May 1, 2026

Knox United Church
92 Northumberland Street
Ayr, ON N0B 1E0

**Re: Servicing Addendum
92 Northumberland Street, Ayr
Township of North Dumfries**

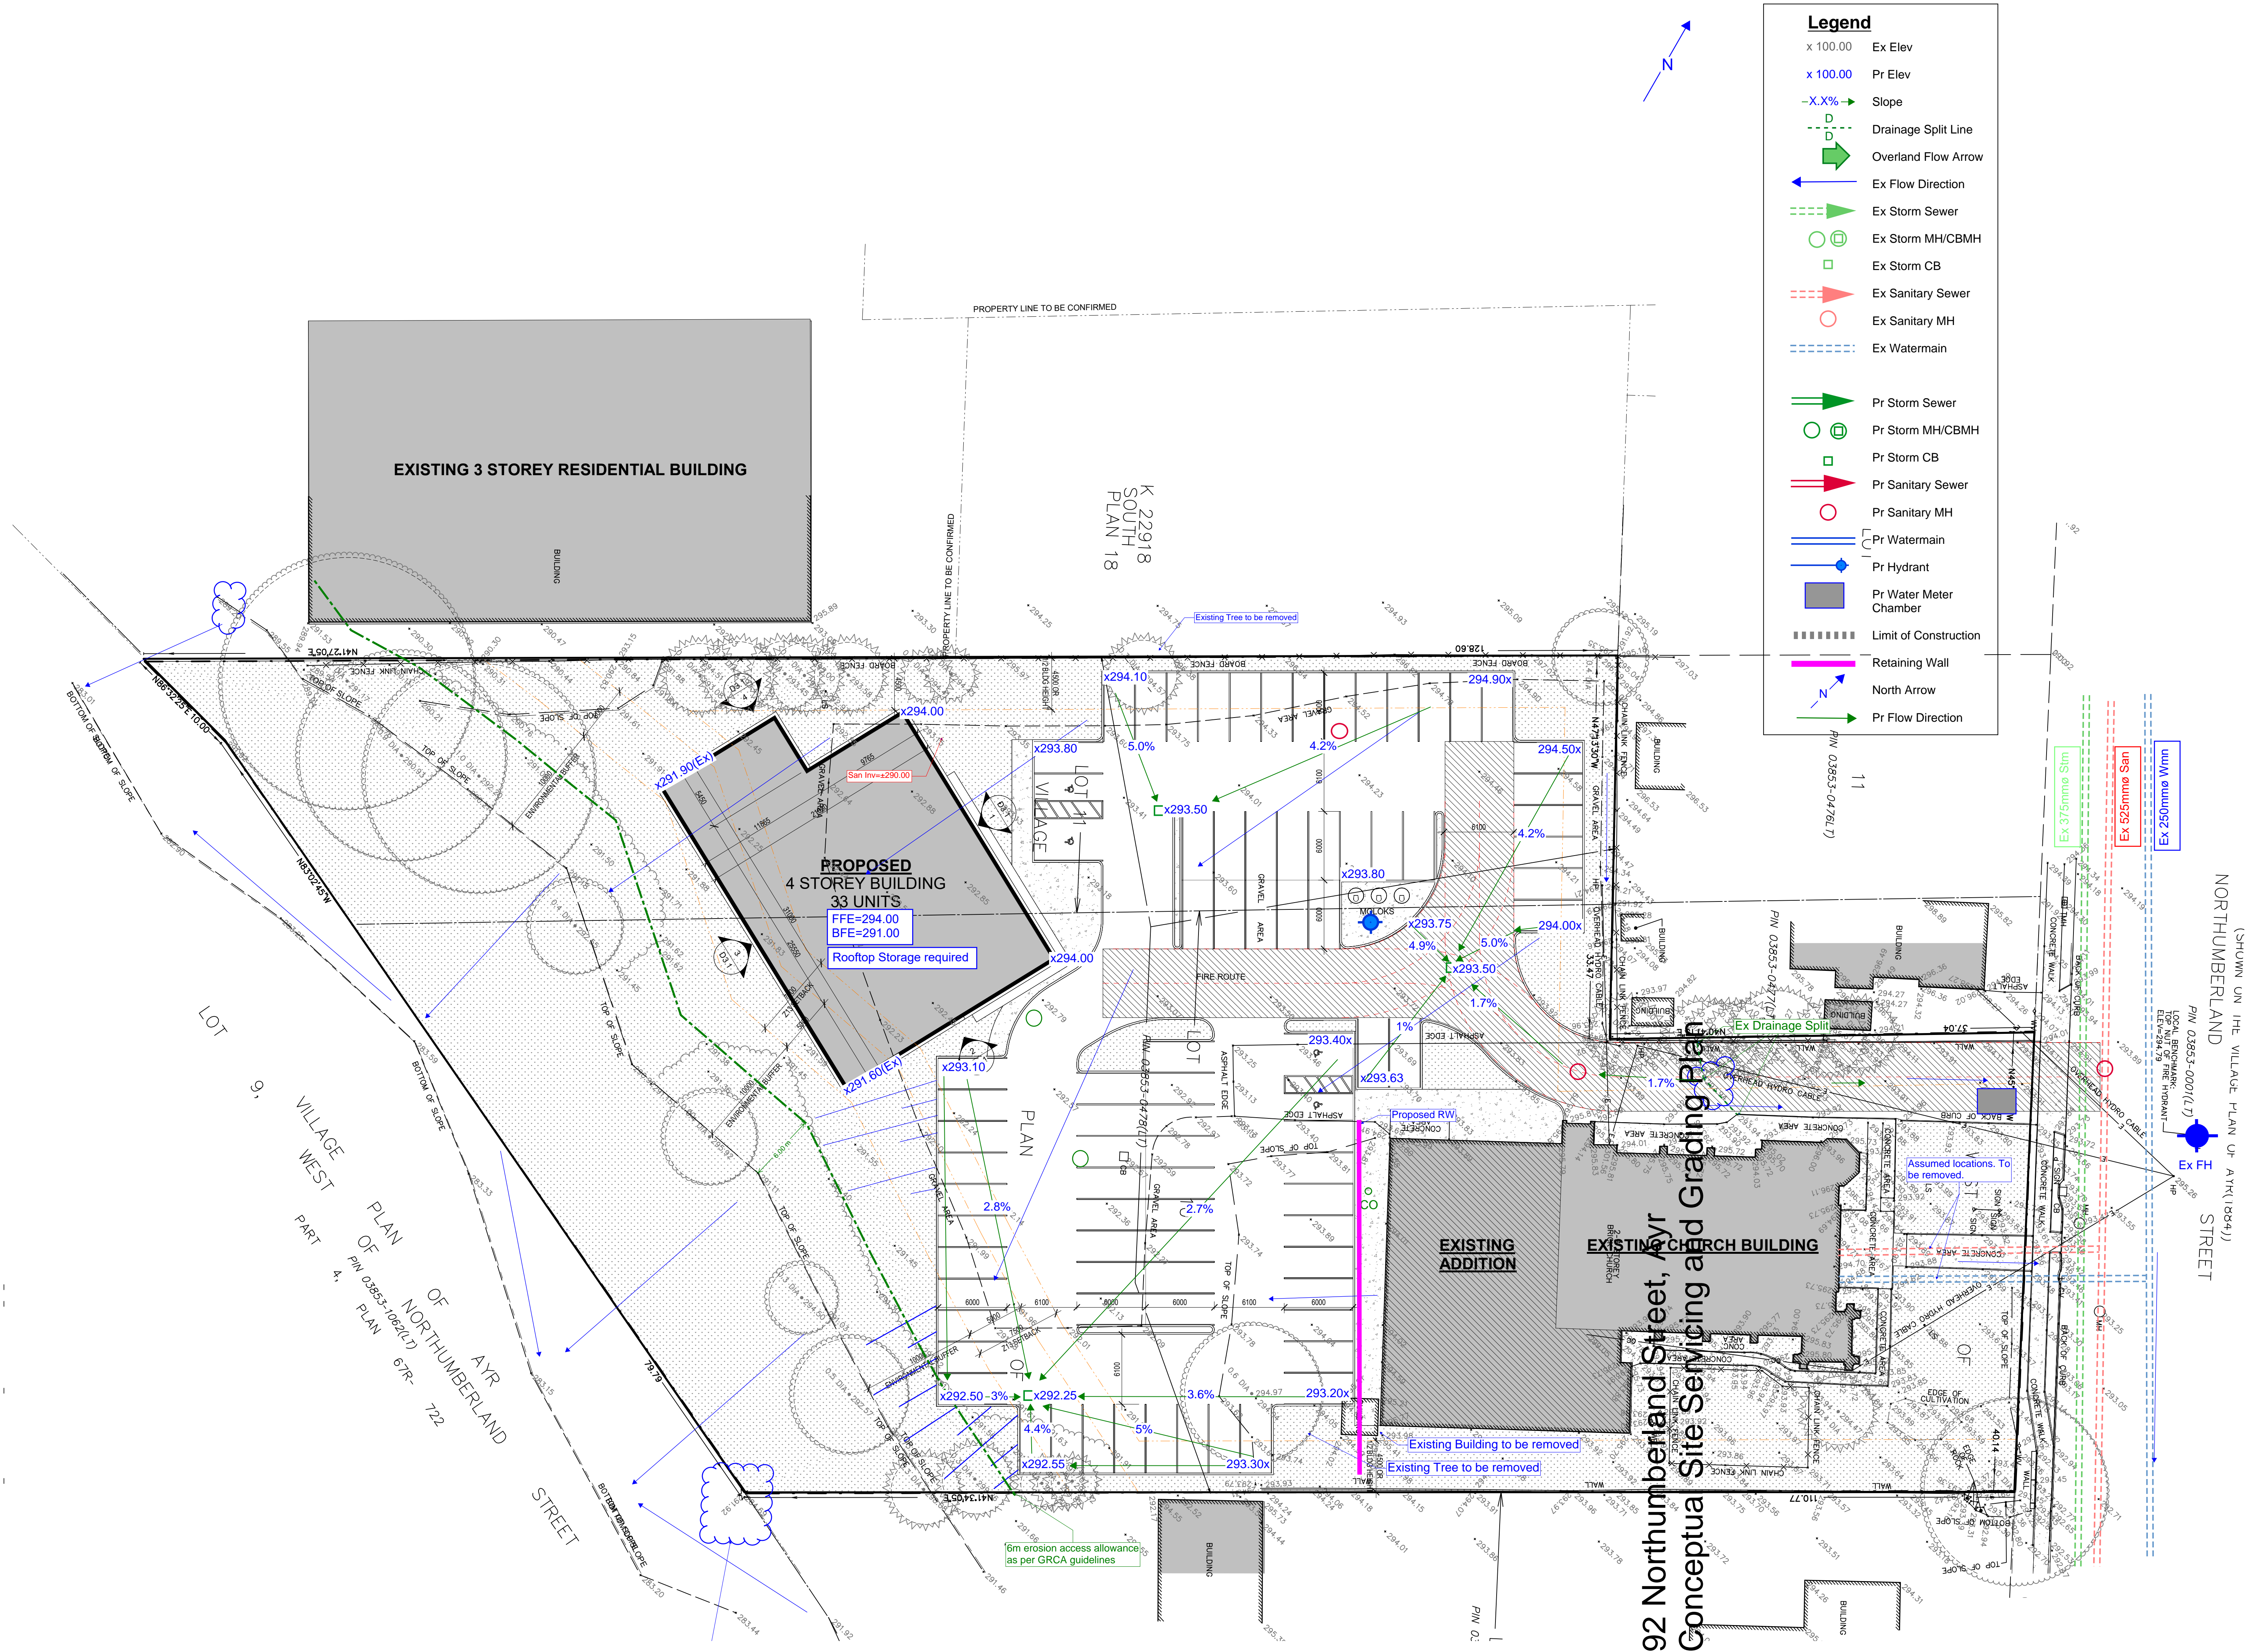
This letter has been prepared for the above-noted project to address the Region's comments in support of the zone change application. The Conceptual Grading Plan and Servicing Plan have been separated into two drawings as requested, and the location of the existing services has been added to the Conceptual Servicing Plan.

The 6m erosion access allowance has been added to the drawings, and the proposed retaining wall has been relocated outside the erosion access allowance.

DRAWING: 92 Northumberland Street, Ayr
 Conceptual Servicing Plan

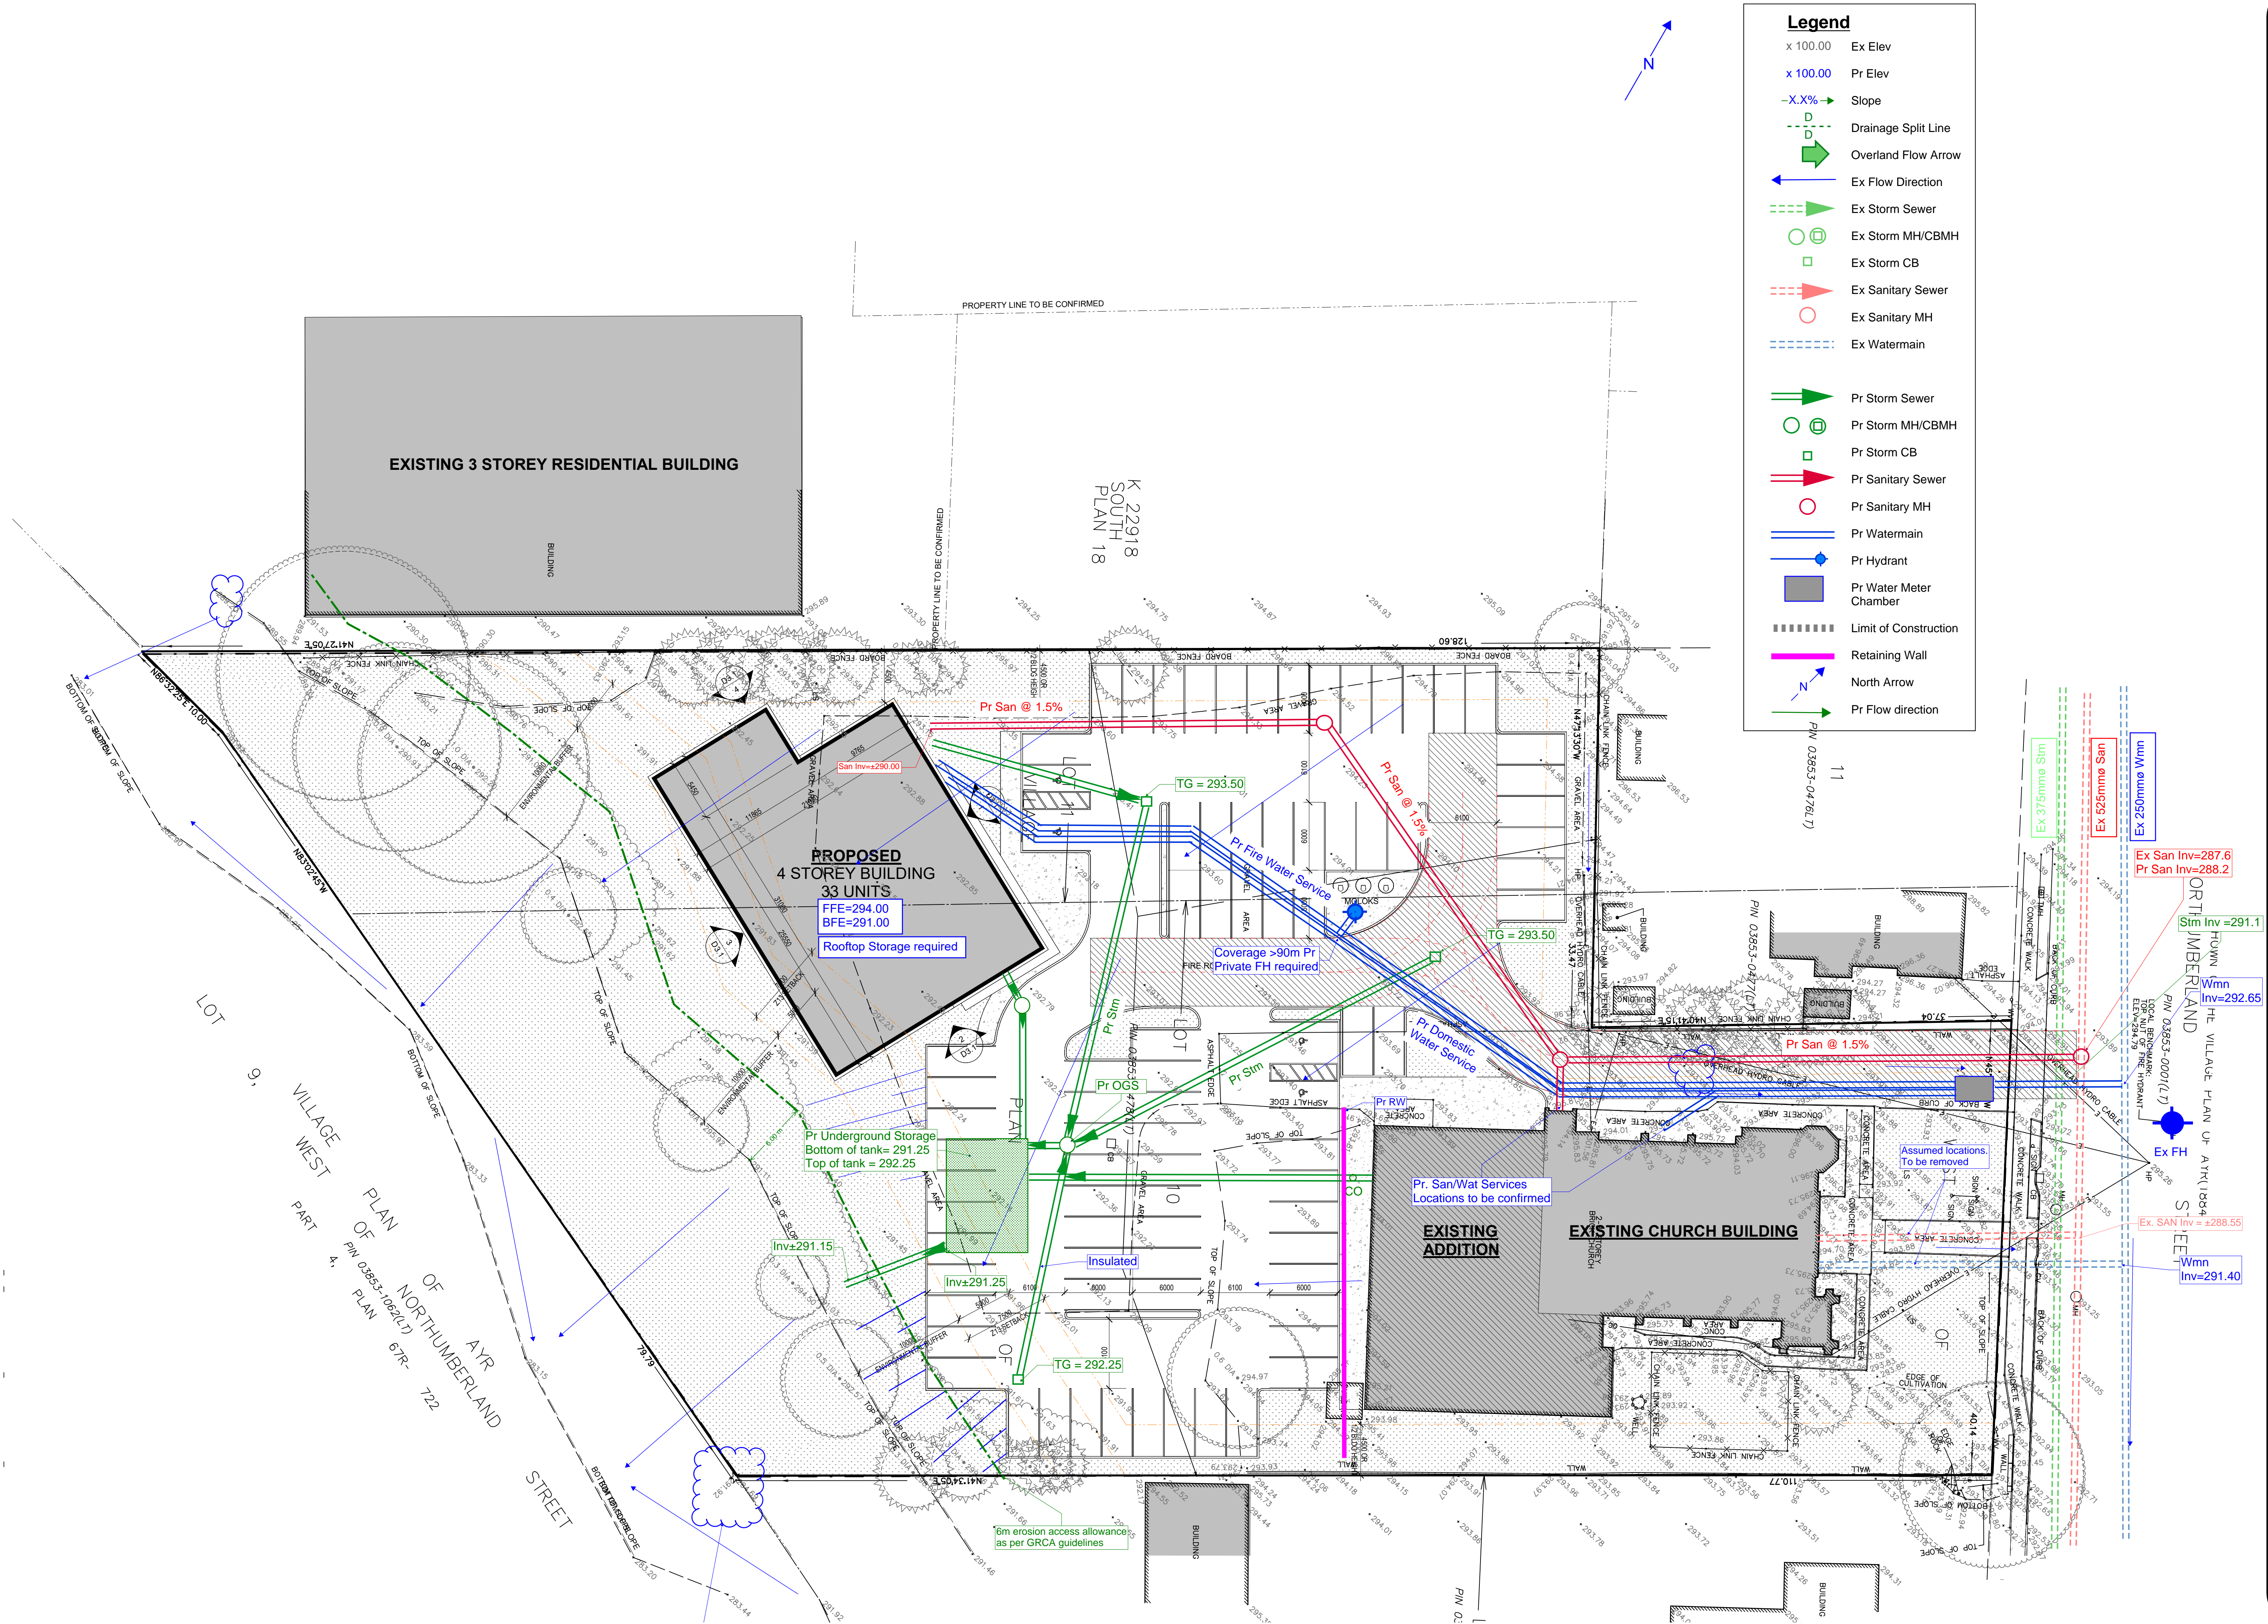
As stated in the Preliminary Servicing and Stormwater Management Letter prepared by Meritech Engineering dated February 27, 2025, the proposed development will generate a base domestic water demand of 0.15 L/s for the design population of 59 people at a base demand of 225 L/cap/day. The estimated firefighting flow is 195 L/s, and the maximum design velocity is 5 m/s. A 250mm diameter water service is proposed to service the proposed building.
